**TO:** Dr. Jesse Bacon, Superintendent  
**FROM:** Danny Clemens, Director of Facilities  
**Date:** May 8, 2024  
**RE:** Bernheim - Change Order 16 - Exposed Ductwork in Flex Room **DC**

**PROJECT:** *(Name and address)*  
Bernheim Middle School Renovation  
700 Audubon Drive, Shepherdsville, KY  
40165

**CHANGE ORDER INFORMATION:**  
Change Order Number: 016  
Date: May 20, 2024

PROJECT:	<b>Bernheim Middle School Renovation Shepherdsville, KY</b>	REQUEST FOR PROPOSAL NO.:	<b>13</b>
OWNER:	<b>Bullitt County Public Schools 1040 Highway 44 East Shepherdsville, KY 40165</b>	DATE:	<b>4-Apr-2024</b>
TO CONTRACTOR:	<b>Calhoun Construction Services, Inc. 7707 National Turnpike Louisville, KY 40218</b>	ARCHITECT:	<b>Studio Kremer Architects 1231 S Shelby Street Louisville, KY 40203</b>
		ARCHITECT'S PROJECT NO.:	<b>2022-36 BG# 23-051</b>

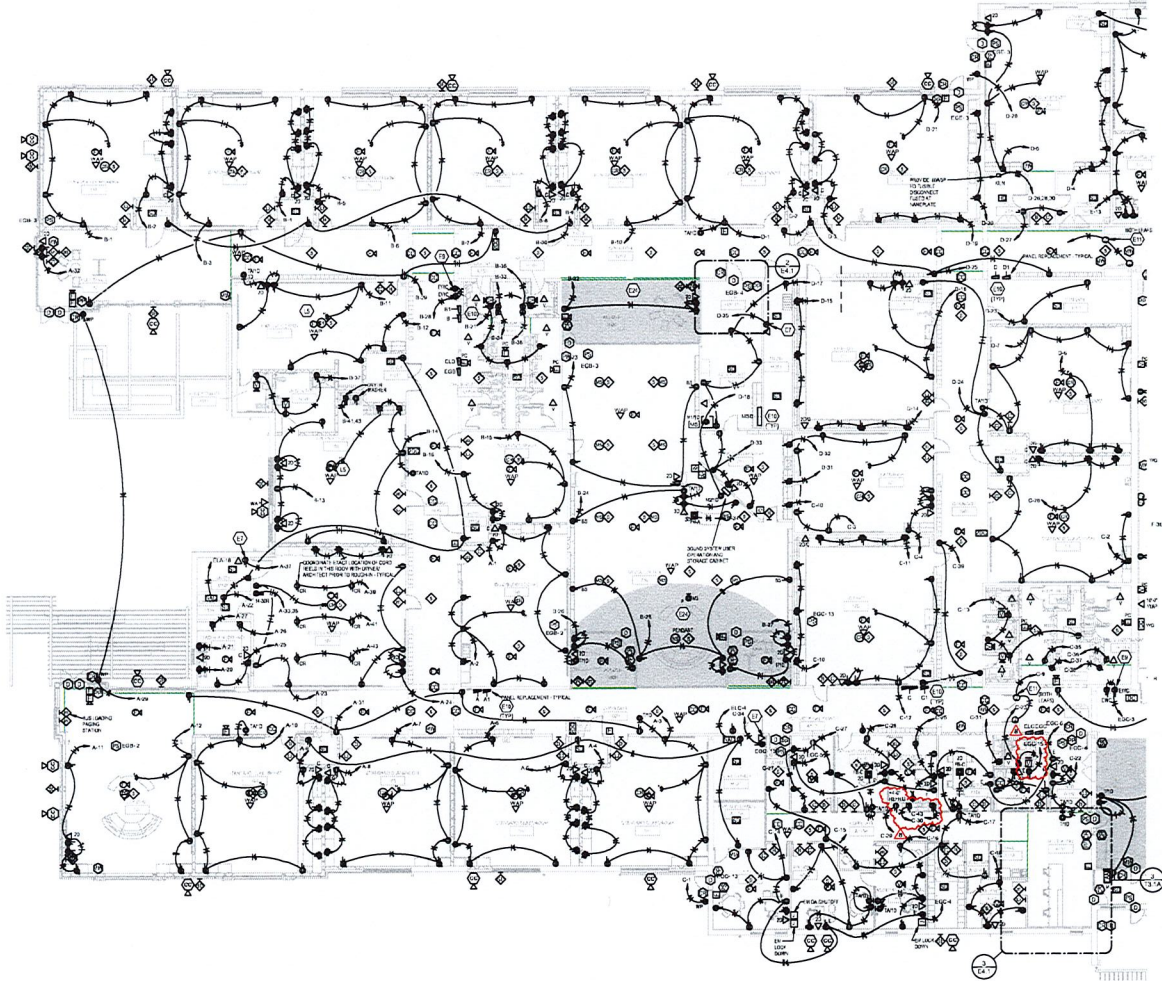
- Item 1:** REFERENCE A5.6
- Extend the countertop along the plan north wall in the Health Room A104
  - Remove the upper wall cabinet, the lower base cabinet and modify the countertop in Corridor A110A to accommodate a full-size refrigerator.
- Item 2:** REFERENCE E4.1
- Refer to corridor A110A. Revise outlet for circuit C-29 to 4'-0" – no counter. Revise breaker to GFCI.
  - Refer to corridor A110A. Add additional above counter outlet for alcove with 20A circuit C-43
  - Refer to health A104. Revise em outlet to a dedicated 20A circuit EGC-15.
- Item 3:** REFERENCE E7.1
- Refer to updated panel schedule "C".
- Item 4:** REFERENCE E7.3
- Refer to updated panel schedule "EGC".
